UNITED STATES PATENT AND TRADEMARK OFFICE

APPLICATION NO.	FILING DATE	FIRST NAMED INVENTOR	ATTORNEY DOCKET NO.	CONFIRMATION NO.
10/785,984	02/26/2004	Hiroshi Yamauchi	500.43535X00	2679
20457 7590 01/17/2007 ANTONELLI, TERRY, STOUT & KRAUS, LLP 1300 NORTH SEVENTEENTH STREET SUITE 1800 ARLINGTON, VA 22209-3873			EXAMINER CANTELMO, GREGG	
			ART UNIT 1745	PAPER NUMBER
SHORTENED STATUTORY PERIOD OF RESPONSE			MAIL DATE	DELIVERY MODE
3 MONTHS			01/17/2007	PAPER

Office Action Summary

DETAILED ACTION

FIG. 7

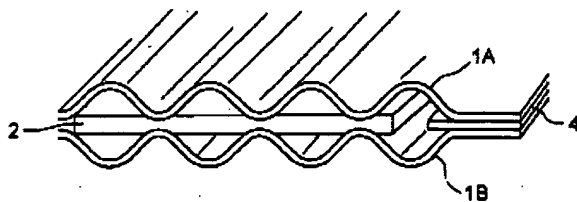
3. Figure 7 should be designated by a legend such as --Prior Art-- because only that which is old is illustrated. See MPEP § 608.02(g). Corrected drawings in compliance with 37 CFR 1.121(d) are required in reply to the Office action to avoid abandonment of the application. The replacement sheet(s) should be labeled "Replacement Sheet" in the page header (as per 37 CFR 1.84(c)) so as not to obstruct any portion of the drawing figures. If the changes are not accepted by the examiner, the applicant will be notified and informed of any required corrective action in the next Office action. The objection to the drawings will not be held in abeyance.

Admitted prior art Fig. 7 discloses a cooling section of a fuel cell comprising a pair of metallic separators at least one of which has corrugated passages; and a gasket 4 in the portion other than the passage plane of the passages (Fig. 7 as applied to claims 1 and 7).

The difference between the admitted prior art Fig. 7 and claims 1 and 7 is that Fig. 7 does not teach of providing an elastic and/or compressive and electroconductive intermediate between the passage planes of the two separator plates of the cooling section.

FIG. 1

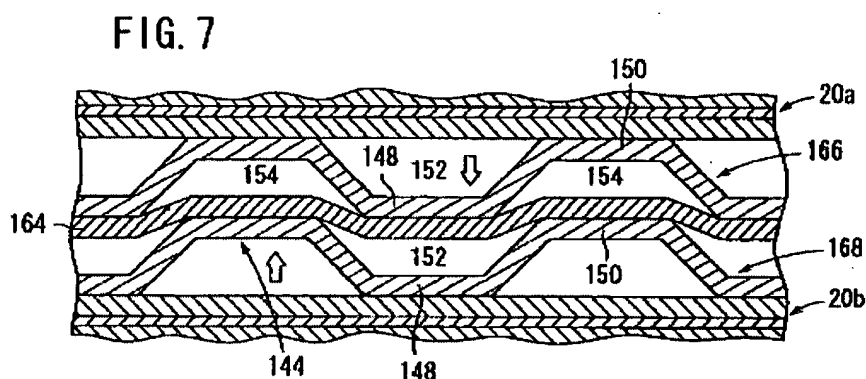
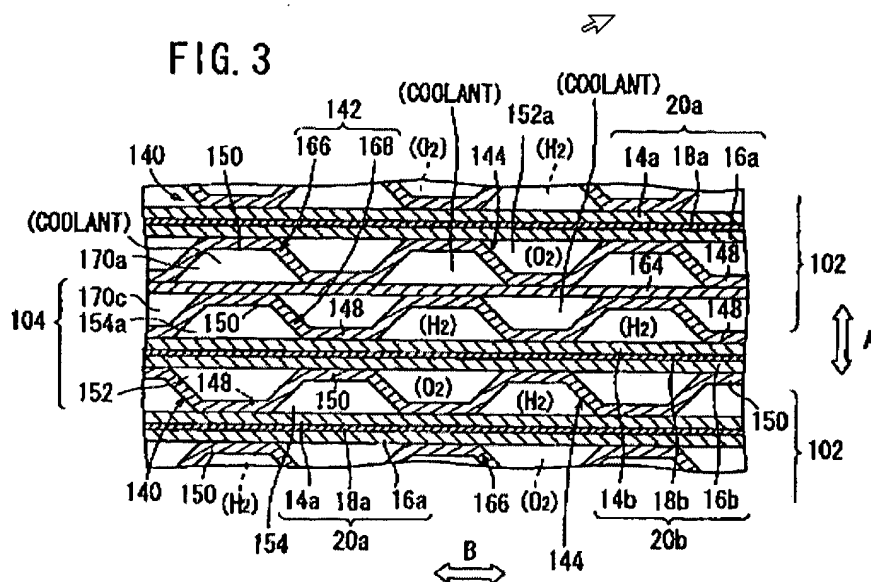
Comparative to the instant applications inventive concept in Fig. 1:

FIG. 7

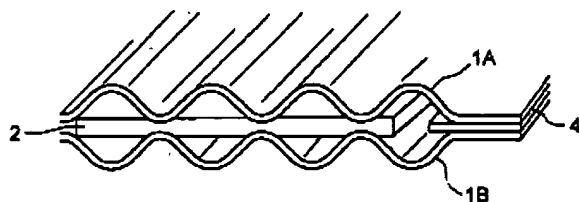
Admitted prior art Fig. 7 discloses a cooling section of a fuel cell comprising a pair of metallic separators at least one of which has corrugated passages; and a gasket 4 in the portion other than the passage plane of the passages (Fig. 7 as applied to claims 1 and 7).

The differences between the admitted prior art Fig. 7 and claims 1 and 7-8 are that Fig. 7 does not teach of providing an elastic and/or compressive and electroconductive intermediate between the passage planes of the two separator plates of the cooling section (claims 1 and 7) or of the intermediate sheet having openings in portions which are not in direct contact with the separator for cooling (claim 8).

Figure 3

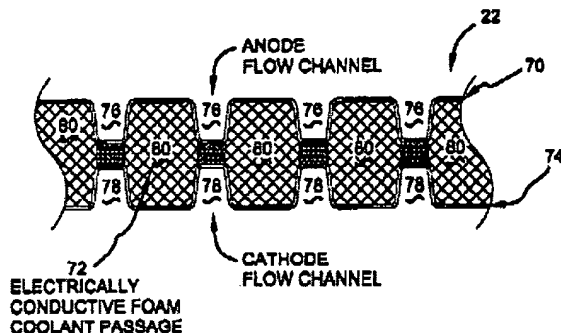
Alternatively Brady discloses providing an electrically conductive foam between adjacent separator plates 70 and 74. The foam 80 is both electroconductive and, as a porous foam, also compressible or elastic (Fig. 3 and abstract as applied to claims 1 and 7).

Furthermore the foam sections include opening portions therein which are not in direct contact with the separator and provide for defining cooling passages in the foam (Fig. 3 as applied to claim 8).

The motivation for using the foam is that it provides for regions of high density to improve the conductive nature of the multilayer separator arrangement and regions of low density which have adequate cooling space and well as a conductive mesh network within the coolant spaces 80.

Figure 3

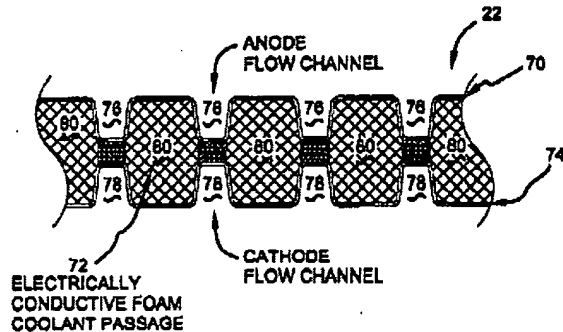
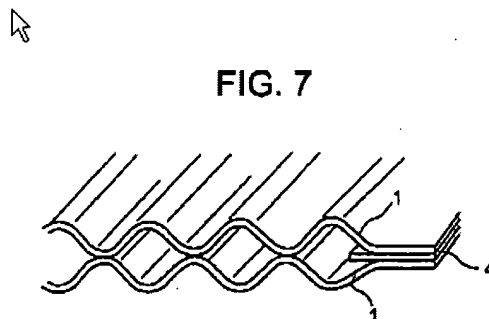
Brady discloses providing an electrically conductive foam between adjacent separator plates 70 and 74. The foam 80 is both electroconductive and, as a porous foam, also compressible or elastic (Fig. 3 and abstract as applied to claims 1 and 7).

Brady discloses a fuel cell stack comprising electrolyte membrane electrodes, gas diffusion layers and a metallic separator (Fig. 1 and col. 3, ll. 5-60) where the separator includes corrugated metal foils 70 and 74 which is further provided with providing an electrically conductive foam 80 between adjacent separator plates 70 and 74. The foam 80 is both electroconductive and, as a porous foam, also compressible or elastic (Fig. 3 and abstract as applied to claim 2).

Furthermore the foam sections include opening portions therein which are not in direct contact with the separator and provide for defining cooling passages in the foam (Fig. 3 as applied to claims 3 and 8).

The foam can be a metal foam, graphite foam or carbon foam. The graphite and carbon foams are equivalent to the broader carbon paper, carbon cloth and graphite sheet as claimed (as applied to claims 4 and 9).
